Supports assembly for barrel insertion chassis and patch panels

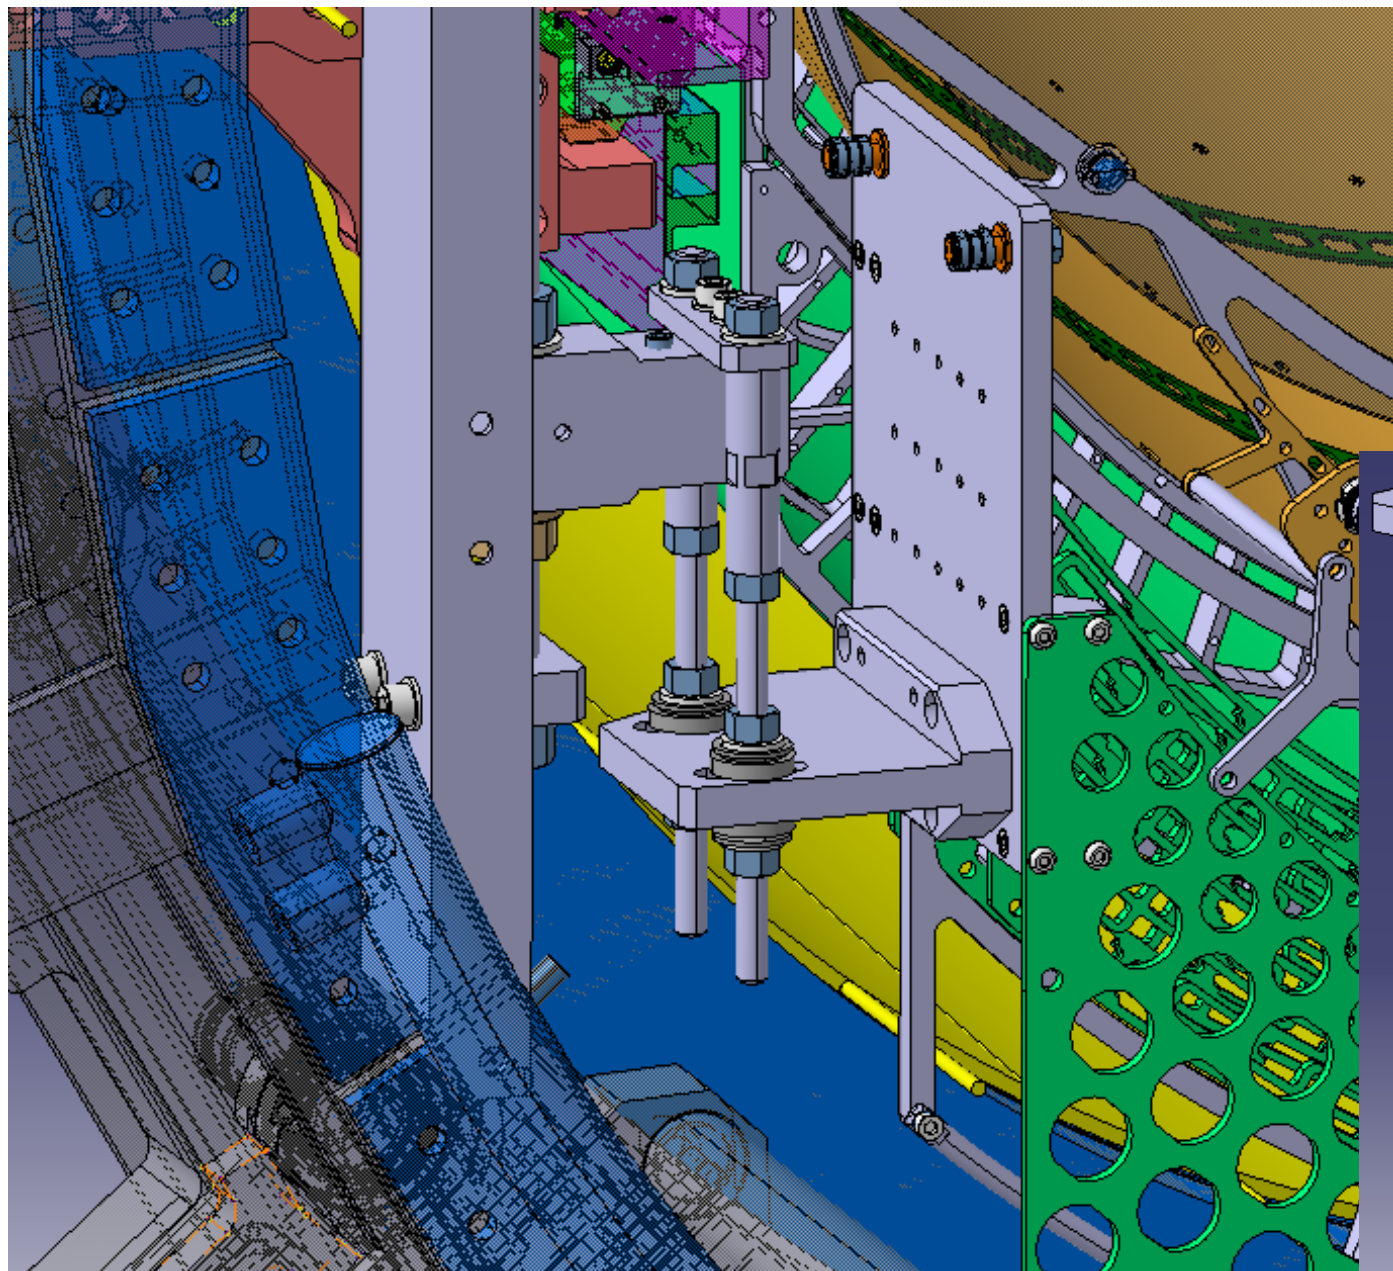
Fixation by 2 M8 screws, could be not enough for the weight and the cantilever apply during the patch panel insertion. Could be improved.
